CITY PLAN COMMISSION STAFF REPORT

June 18 2025

Project Name
Jay Wolfe Toyota Expansion

Request
CD-CPC-2025-00058
Major Amendment to a Development Plan

1 | Landscape Plan
scale: 1" = 50'-0"

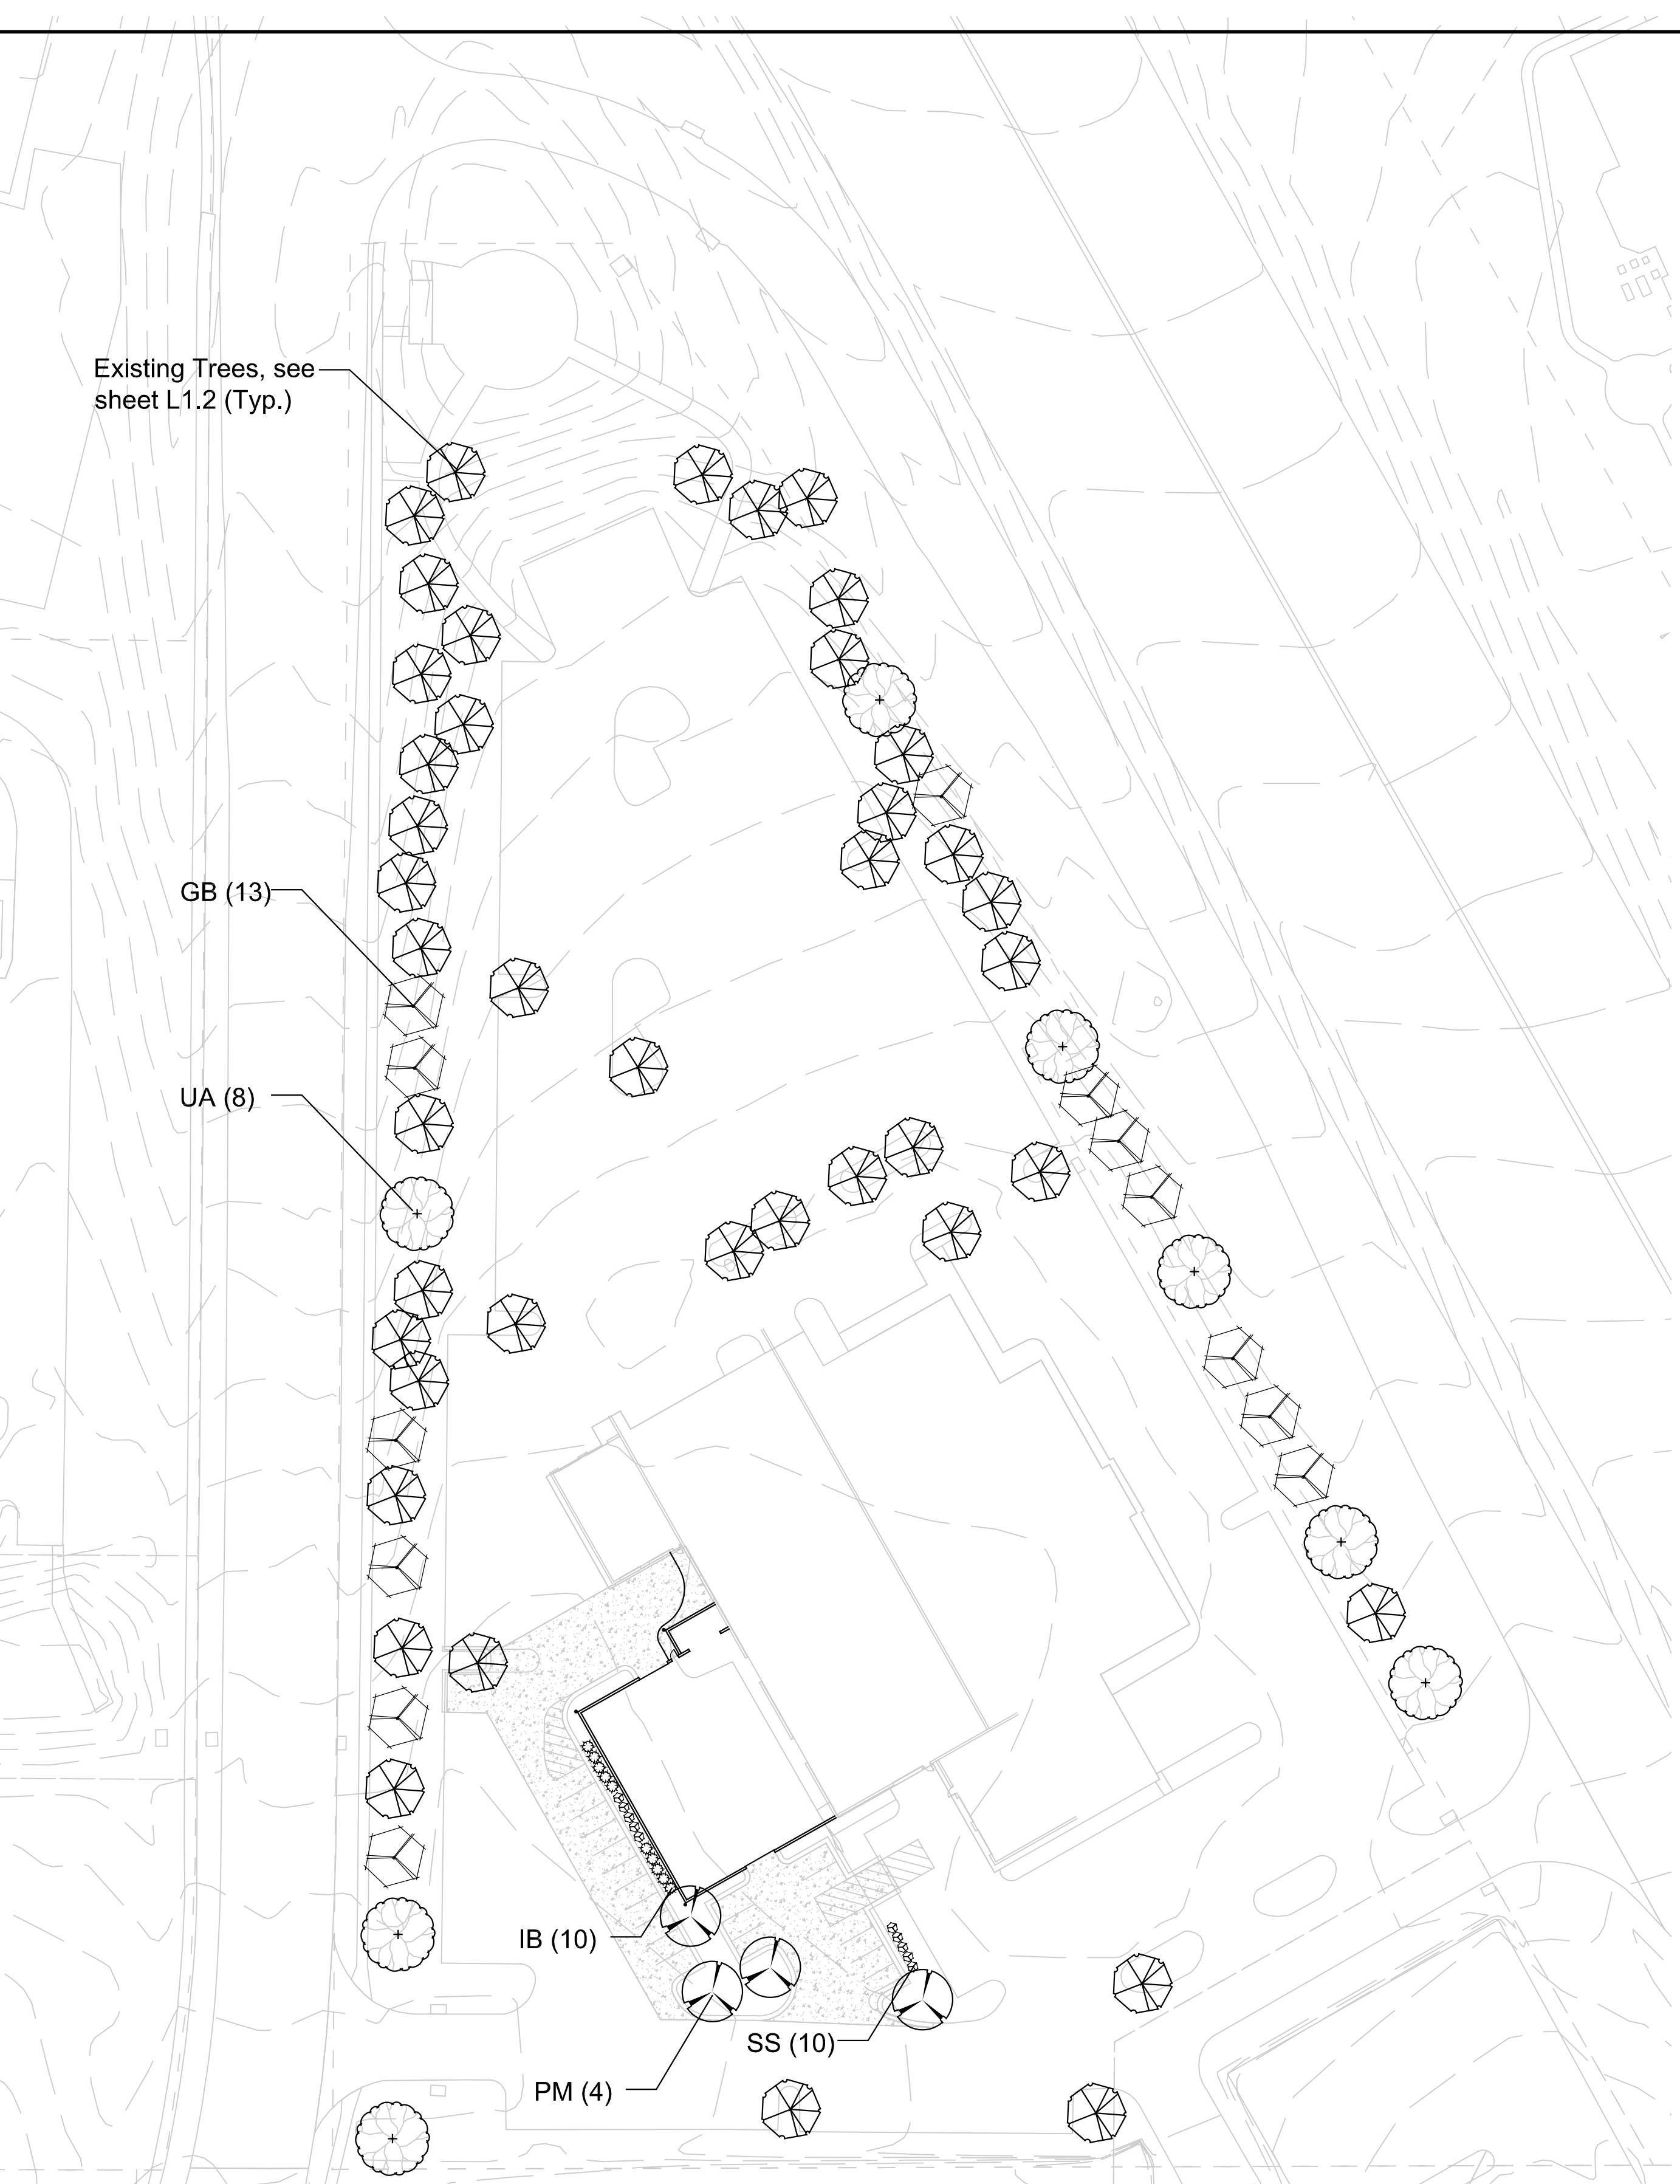
better meet the "well-designed city" goal, enhanced landscaping along the eastern side of the site is recommended as I-29 is designated as a primary image street by the KCI area plan." - Alexis Berra

The proposed project helps advance some of the KC Spirit playbook and KCI Area Plan goals. The proposed addition matches the “commercial” future land use designated by the KCI area plan. To better meet the “well-designed city” goal, enhanced landscaping along the eastern side of the site is recommended as I-29 is designated as a primary image street by the KCI area plan.
